To: Garrett Crowe
From: Jim Antonopoulos
Date: 13 September 2022
Subject: Emmanuel College Warrnambool
Year 9 Centre
Acoustic Review

At: Baldasso Cortese
At: SLR Consulting Australia Pty Ltd
Ref: 640.30538.00000-M01-v0.2-20220913.docx

Further to our acoustic workshop on 7 September we provide herein our review of the current architectural drawings and design for the Year 9 Centre at Emmanuel College

3.2 Cavity Walls for Sliders

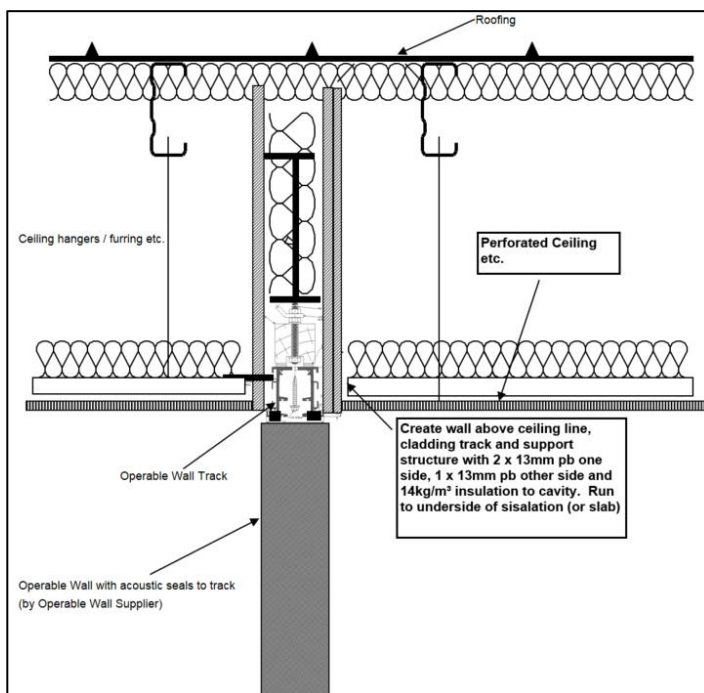
Cavity wall sliders will require a twin stud wall arrangement. This is an appropriate construction for these locations and the wall will achieve above R_w 45 dB.

Note if a lining is required to the inside of the studs (to ensure insulation does not fall within cavity slider zone), provide wire, perforated pegboard, perforated plasterboard or other 'open' material to hold insulation in place.

3.3 Operable Wall – Presentation Space

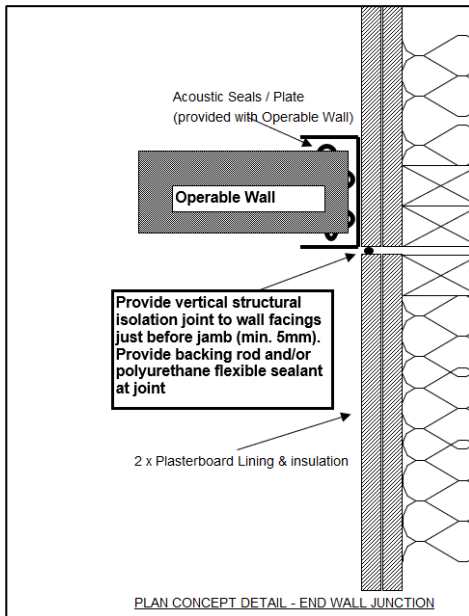
A reputable make of operable wall should be nominated (eg. Lotus or Glyde) with a laboratory rating of not less than $R_w=45$ dB.

We note that the head, bottom and perimeter sealing details should be provided by the supplier of the operable wall and are critical to implement if aiming to achieve a field rating close to that of the laboratory rating.

In addition, perimeter ceiling and wall details are also critical. The following provides concept details for operable wall head and perimeter treatments.

3.4 Sliding Doors

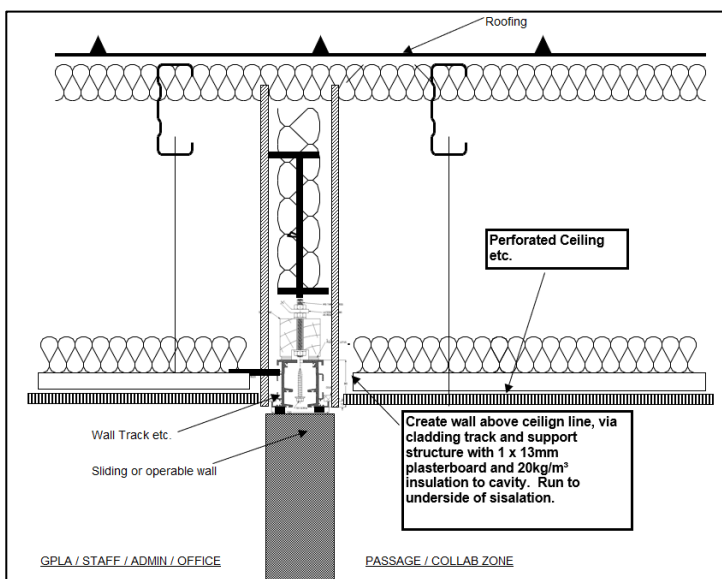
Acceptable acoustically rated sliding doors are available from Lotus and Glyde and should be selected to achieve not less than R_w 30 dB. The doors are to be installed in accordance with the manufacturer's recommendations with effective sealing and detailing at the top, bottom and perimeter.

Note that the area above the sliding doors (ie effectively the separating wall between all rooms and the passageway / breakout zones) need to include partition constructed slab to slab in the case of the ground floor, and to the underside of the roof structure / pushed against sisalation on the upper floor. The concept is shown below. The wall section above the ceiling line only needs 1 layer of plasterboard to each side of the frame (and insulation in the cavity) as opposed to the walls that separate the main teaching spaces.

3.7 External Façade Junctions

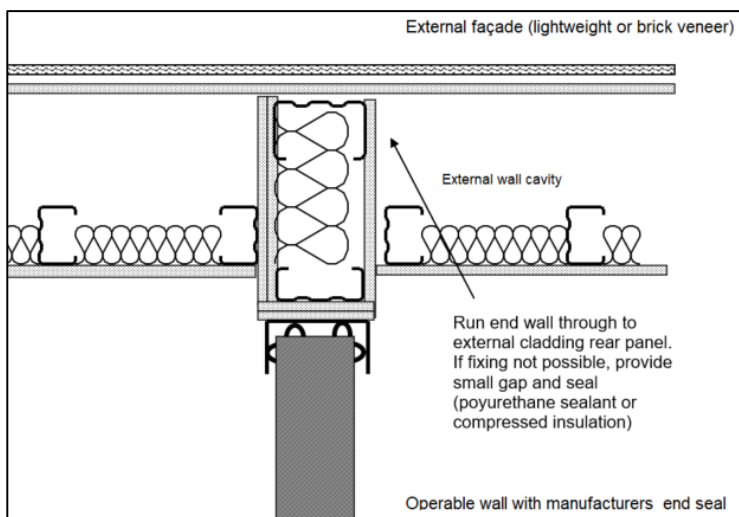
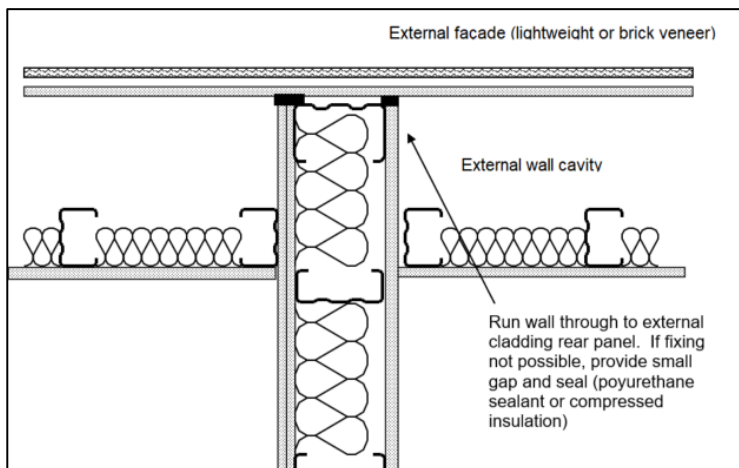
Ensure all partitions penetrate the façade glazing framework.

As a rule any separating wall that meets with the external walls will require the separating wall to continue through the external wall inner linings, and seal as practicable to the external façade element.

The images below show conceptually how this can be achieved (for lightweight external walls).

1 GROUND FLOOR PLAN
008 SCALE - 1:200

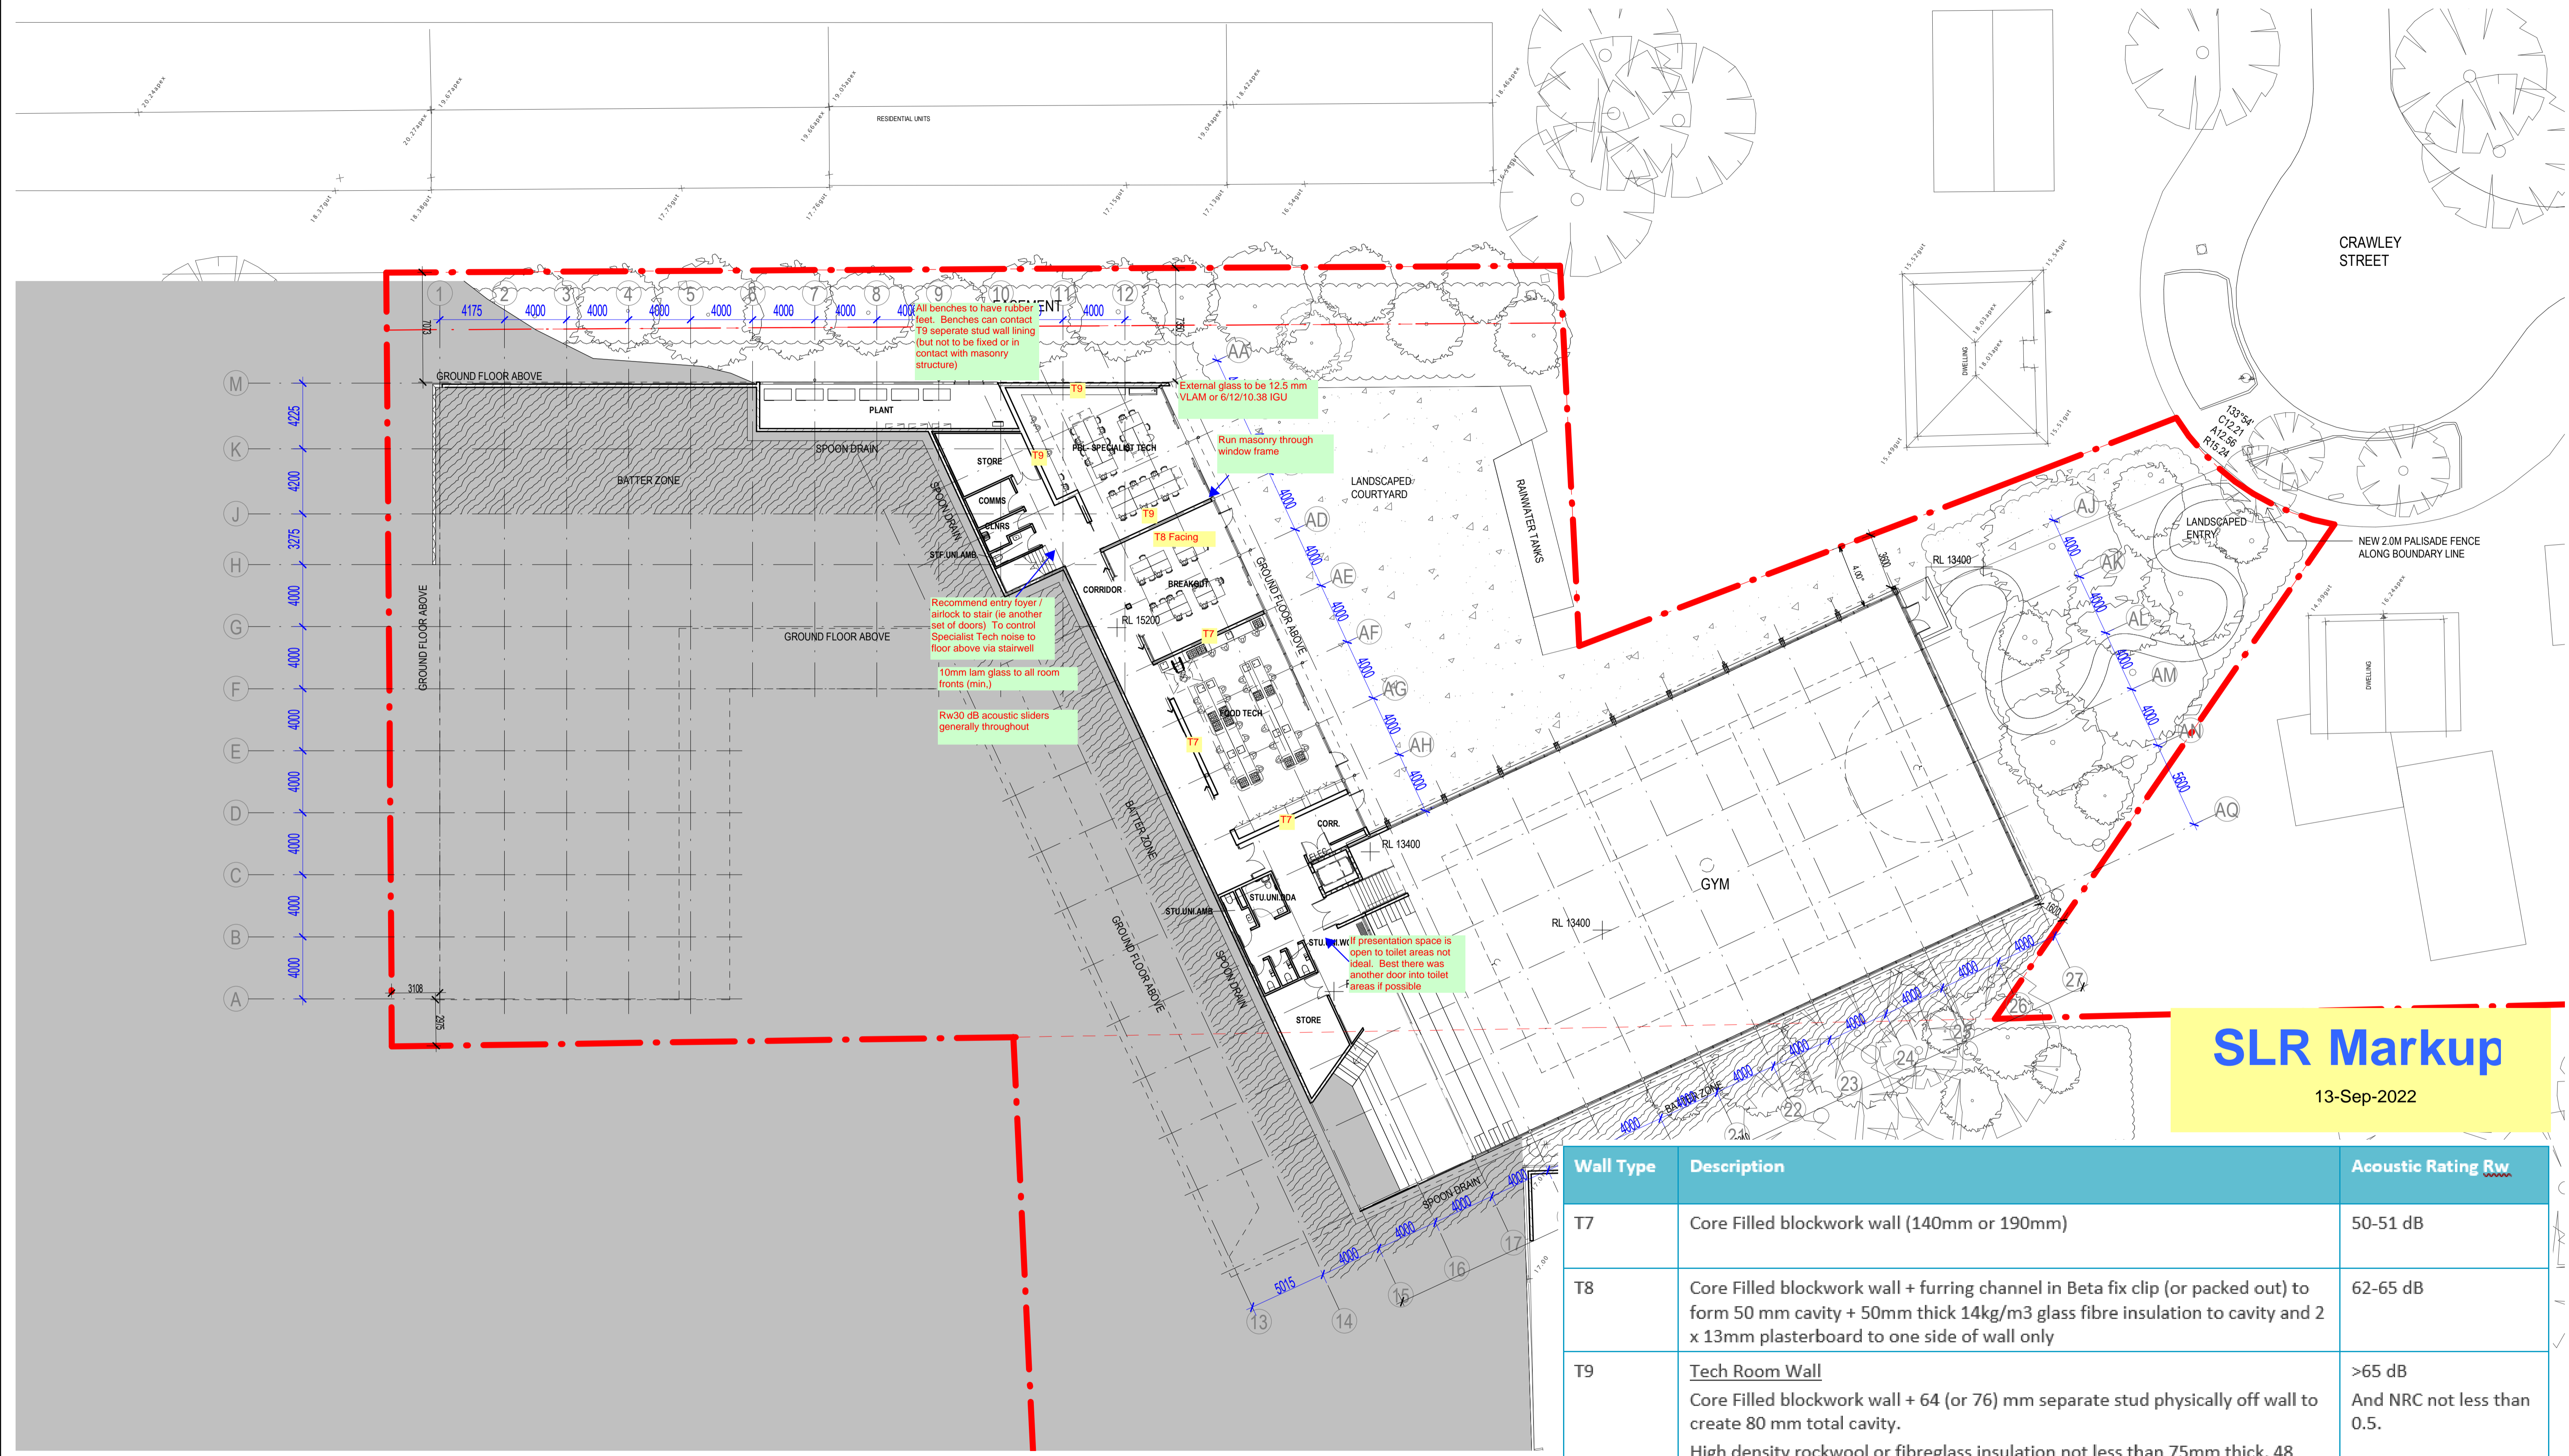
- T2 to run through above ceiling line for glazed partitions / roomfronts
- 10mm lam glass to all room fronts (min.)
- Rw30 dB acoustic sliders generally throughout
- Where a T3 or T5 wall is nominated, the double layer of plasterboard is to be on the more sensitive room - i.e. the room that is at risk of receiving impact noise from an adjacent space (such as from benches, lockers, toilets)

SLR Markup
13-Sep-2022
